Potential for Tree Damage Due to Glenwood Hills Reservoir 2 Access Road Construction Project

Joran Viers, Senior Partner
Root to Shoot Urban Forestry Inc
7/20/2021

Situation Statement and Preliminary Observations

Image 6: prune dead and living branches back from power lines using reduction cuts to existing side branches well outside powerlines.

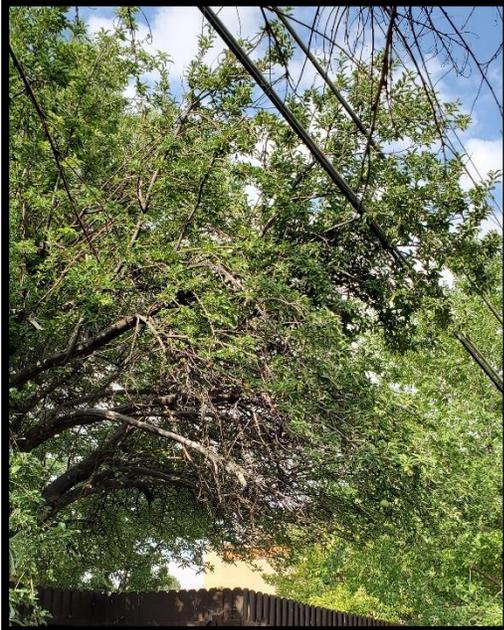
2. Russian olive: undesirable (except by wildlife), 2 main stems at 8" or less DBH, 20 feet tall. Good condition, in grub and clean area so will be cut down. Growing into power lines, may require PNM contractor to do initial pruning to clear the wires prior to contractor completing removal.
3. Apple: desirable, south side of wall on private property, approximately 14"DBH, 15 feet tall. Some of tree's north side root zone is in the area slated for grubbing and clearing. With care, the area can be minimally impacted that close to the fence. Continuing and perhaps augmenting irrigation on the private side is best mitigation option. Tree should have north-side branches pruned back from power line (Image 6).

Image 10: mimosa tree showing thin canopy, dead branches due to ongoing water stress.

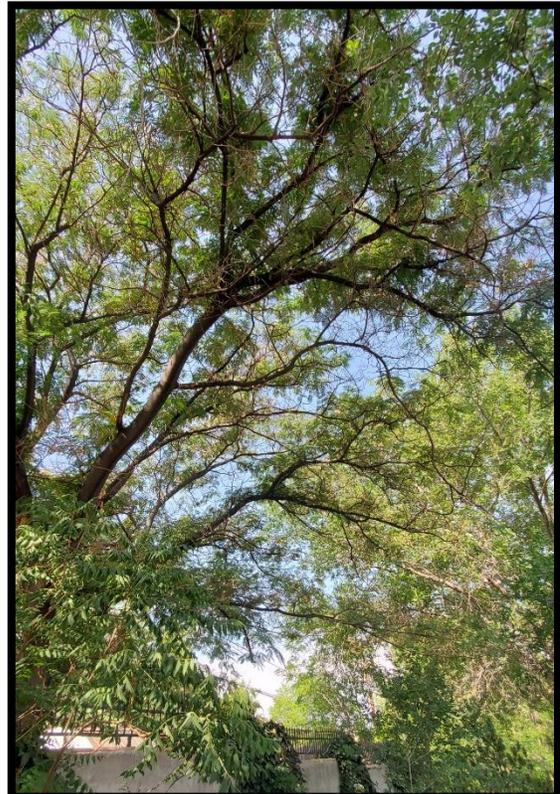
15. Mimosa: desirable, 16" DBH, 25 feet tall, fair condition. large for species, showing signs of water stress already (dead branches, thin canopy; see Image 10). Roadway will touch outer part of root zone; damage should be minimal (***tree is already showing decline and may be/become infected with verticillium wilt***). If owner wants to keep tree they will need to irrigate appropriately. No pruning required for clearance.

Image 11: mimosa sapling to be removed due to proximity to wall.

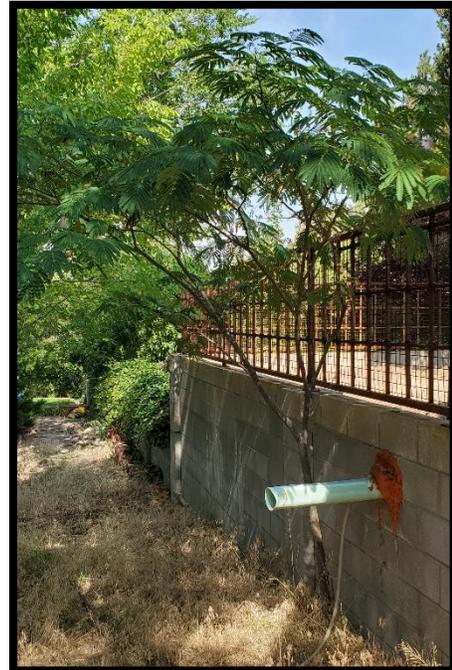
15.a. Mimosa sapling: desirable species, bad location – directly north of tree 15, growing very close to cinderblock wall, should be removed to prevent infrastructure damage; it is also growing with a strong lean to south, putting it on growth path into roadway space (Image 11).

Image 12: Siberian elm roots at surface. Roadway to go right next to tree trunk and over these roots, damaging them severely. Roadway will impact drainage running adjacent to tree trunk.

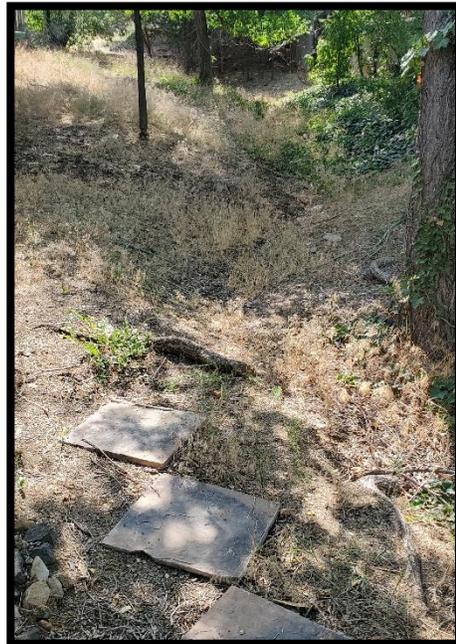
16. Siberian elm: neutral, 16" DBH, 45+ feet tall, good condition. Species is very invasive but grows well in our difficult environment. This tree has been selected to remain but will suffer serious, potentially catastrophic root zone damage both at roadway (completely violates CRZ, large surface roots present now, see image 12) and around outflow area (due to extensive cutting and grade reduction below/around outflow). Damage to large size and large number of roots will almost certainly lead to canopy decline due to lack of water, internal decay due to wounds on root system, and quite possibly to destabilization of the entire tree – wind fall chances will increase dramatically with close root damage. Given the closeness of root damage to the trunk, this tree is one that may present a stem failure potential several years post-construction, when root decay has advanced enough to destabilize the stem. Consider removal.

Images 13 (above) & 14 (below): Raywood ash that will have massive root damage to south side. Clearance pruning will be required approximately along the red line.

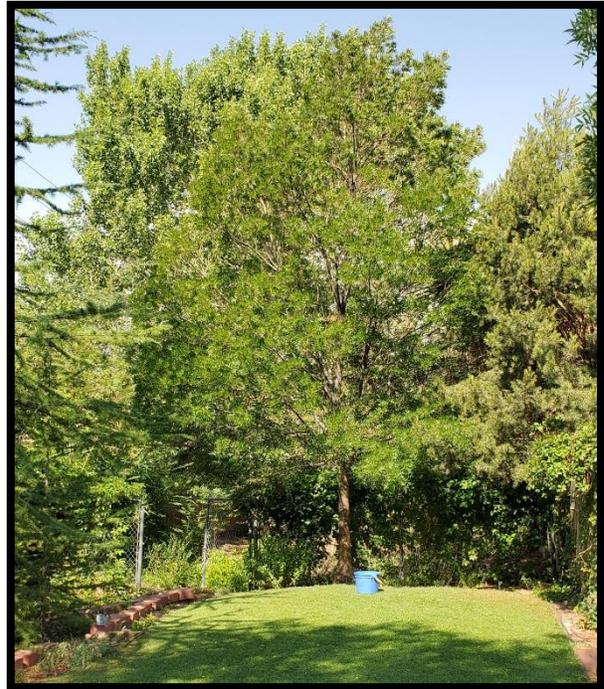
18. Raywood ash: desirable, 6" DBH, 25 feet tall, good condition. This tree will suffer severe root zone damage within the CRZ on the south side. There will be significant dieback of branches on that side, and tree destabilization is a strong possibility due to proximity of root cuts that are very likely to occur (Images 13 &

14). The entire drainage and hydrology on the adjacent south side of the tree will be changed by the construction work. On the positive side, neighbor who planted the tree has been irrigating regularly in areas that will not be impacted by the work, including under the artificial turf. This turf product should be removed, and drip tubing installed such that the footprint of applied irrigation covers a large area east of the tree. This should then be covered up deeply with wood chips, 8-10 inches deep. That will protect the lines and the soil during construction. Post-construction, the wood chips can be spread out to a thinner, 3-inch-deep layer around the root zone to both east and west sides.

Image 18, left: hybrid poplar in background, root sprouts growing from 3" roots in foreground, near Tree #18.

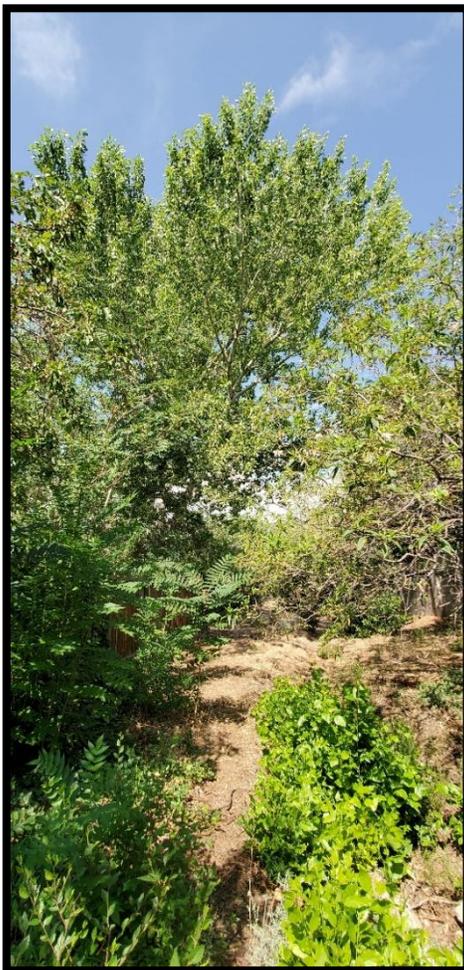
23. Hybrid poplar: neutral (fast growing, quick shade; high water, short lifespan, prone to large branch failure), 26" DBH, 65+ feet tall. Good condition, large tree with multiple long, tall branches typical of species (Image 18). Root zone damage to this tree will be catastrophic: root sprouts coming up at least 50' away in arroyo and multiple large roots in and crossing arroyo, up to 8" diameter (Image 19). No irrigation on south side of tree in owner's yard, so this tree gets almost all its water from the arroyo and the neighboring yards on the north side of the arroyo. Many large, long roots will be cut, buried, compacted, broken and otherwise damaged. Poplar trees (cottonwood relative) do NOT protect their wood well against decay or disease organisms, and once the root damage is done, the tree will quickly decline, die, and begin falling apart. This may take a long as 5-7 years but may be quicker.

I STRONGLY RECOMMEND REMOVAL OF THIS TREE AT THE START OF THE PROJECT. IT WILL BE MUCH MORE COMPLICATED IF LEFT TO DECLINE AND THEN DEALT WITH. IF THE NEIGHBOR IS NOT AGREEABLE, UNDERSTAND THAT COURT PRECEDENT ALLOWS EASEMENT OWNER TO ADDRESS ANY LIMBS OR BRANCHES ON THEIR SIDE OF BOUNDRY.

Image 20: young honeylocust, well out of work zone.

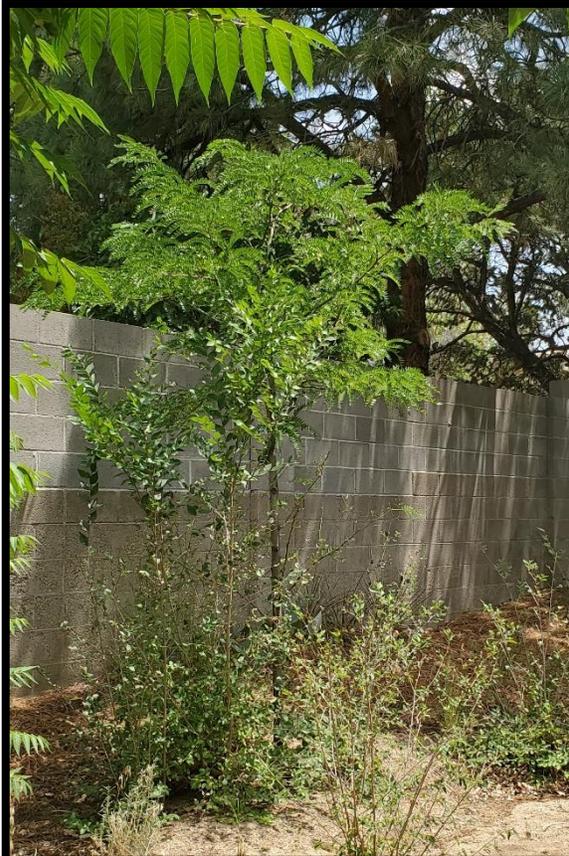
24. Honeylocust: desirable, 2” DBH, 8 feet tall. Good condition. With care, should not suffer any significant root zone disturbance. Mitigation is not needed, though neighbor (who planted tree) should increase the area being irrigated and the amount of water applied (Image 20).
25. Pinyon pine: desirable, 16” DBH, 20 feet tall. Good condition. Minimal root zone damage expected, minimal impact. Pruning might be done on one long, low branch – one 3.5” reduction cut on lower limb (Image 21).
